SAT-4da

Release Candidate

Version 1.07-rc2

23.04.2026

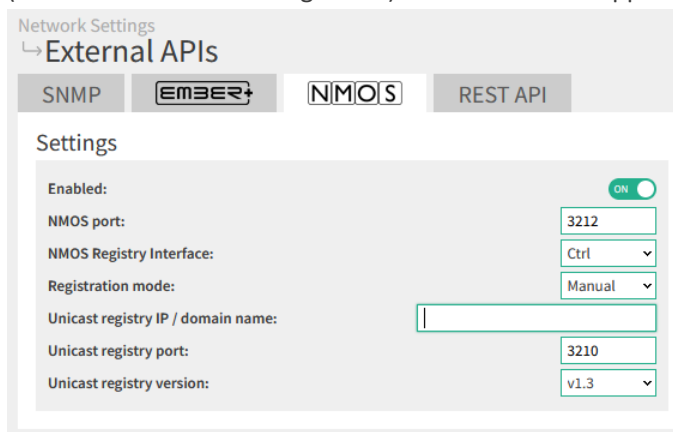
- The NMOS implementation was updated and enhanced. Besides the already existing support for IS-05 (Device Connection Management) we do now also support IS-04 (Discovery & Registration).

In addition to the manual registration mode the registration can also be done via mDNS and DHCP.

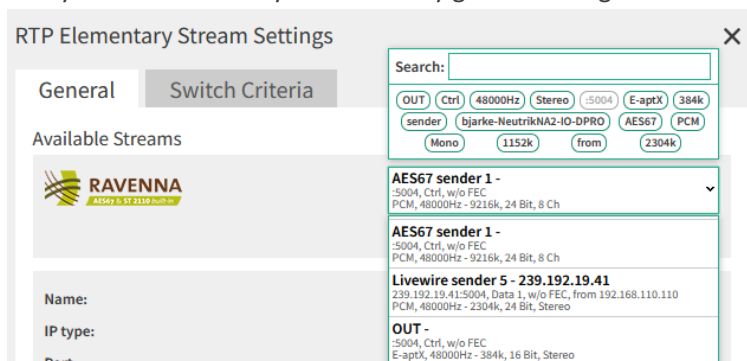
- The list of available Ravenna streams may get long. Now we've added the possibility to filter the list by a freely entered text or by automatically generated tags

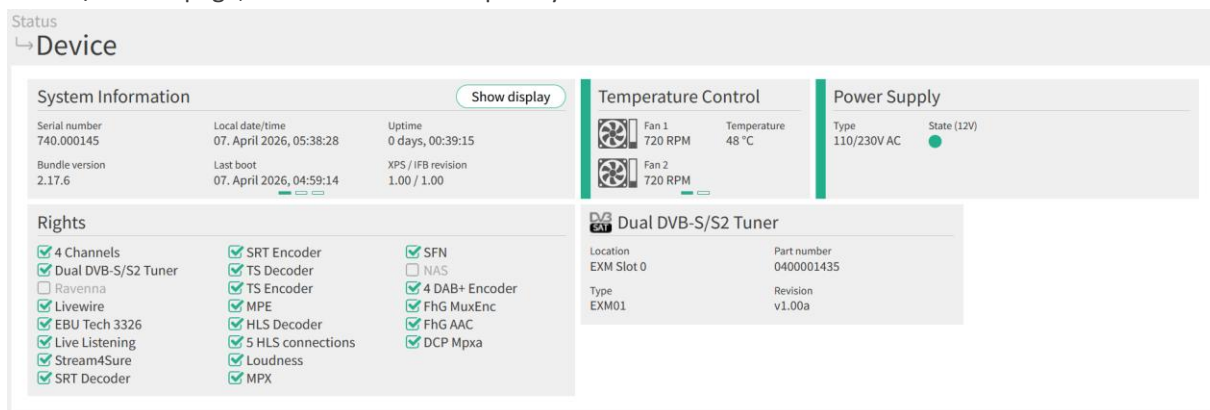
- The System Information, which was formerly found under System Settings / Global, has been moved to the Status / Device page, which has been completely revised

The System Settings / Global page looks therefore of course different now, too:
